Proposed corrections and clarifications to Fault ride through legal text CC

CC.6.3.15 Fault Ride Through

Proposed corrections and clarifications to Fault Ride through requirements ECC

Figure CC.6.3.15(a)(i)(a)

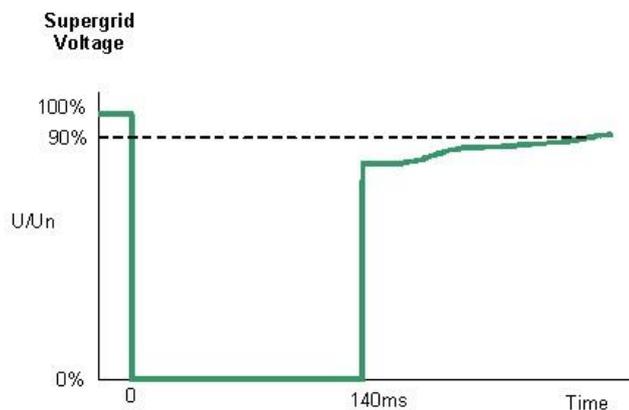
Commented [AF1]: This is to separate the requirement for a machine to be capable of riding through the worst possible event and therefore survive most events from what actually happens with a local event.

Commented [AF2]: This needs clarified or removed as written it potentially means the ride through durations could be shorter than 140ms

AJ Response – I think this works. We would need studies to demonstrate this but whatever we put in the words there will always be some wriggle room which is why we have a compliance process. The context here is to ensure a machine remains connected and stable during a fault whilst remaining connected to a healthy circuit.

AJ response – Agree – Note this is the CC's not the ECC's. It should really be changed to read up to 140ms. We would not wish it to state 140ms otherwise it will have retrospective impacts for plant already connected.

Figure CC.6.3.15(b)

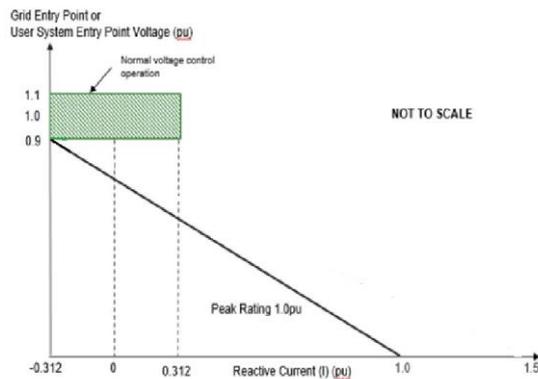
Commented [AF9]: this change is changing active power recovery from 90% of pre-fault level to active power to recover to pre-fault level plus or minus 10% of rated capacity to deal with low load or synchronous condenser operation

This cannot be achieved. It is a wind farm say and the wind speed is only low it will not be able to generate at rated capacity.

Figure 5a

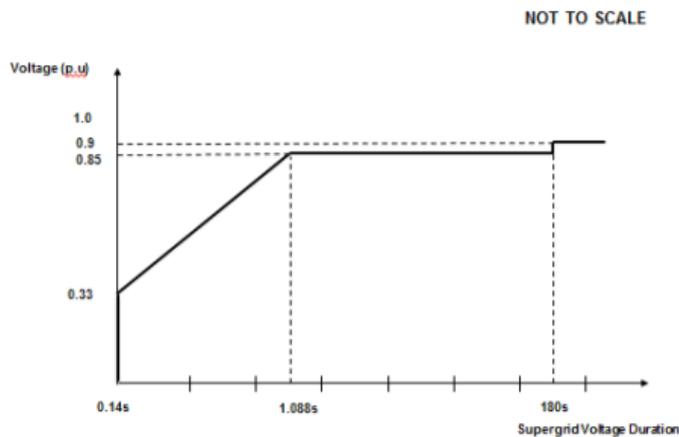
Commented [AF10]: This has been changes as no one actually does what is currently written, this graph is similar to those agreed for GC111 and GC0137 the value might need adjusted. It is written based on non-synchronous as synchronous responses will pass this easily

AJ response – As this is in the CC's it may have unintended consequences for existing plant. There is also a huge range of other requirements linked to this so need to be careful that anything that links to this diagram is not excluded.

Figure 5b

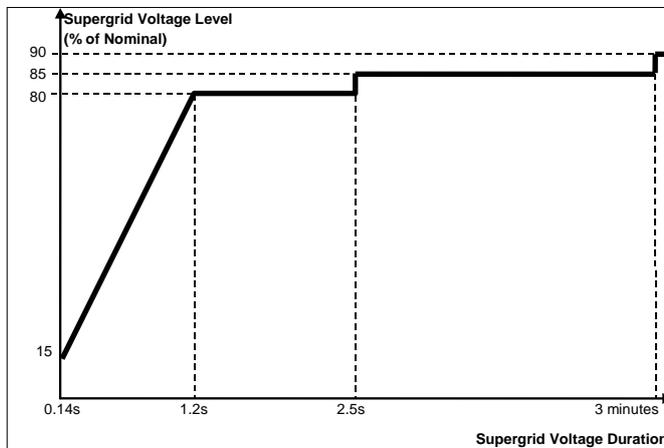
Commented [J(A12)]: Again – See comment above regarding Fig CC.6.3.15(b)
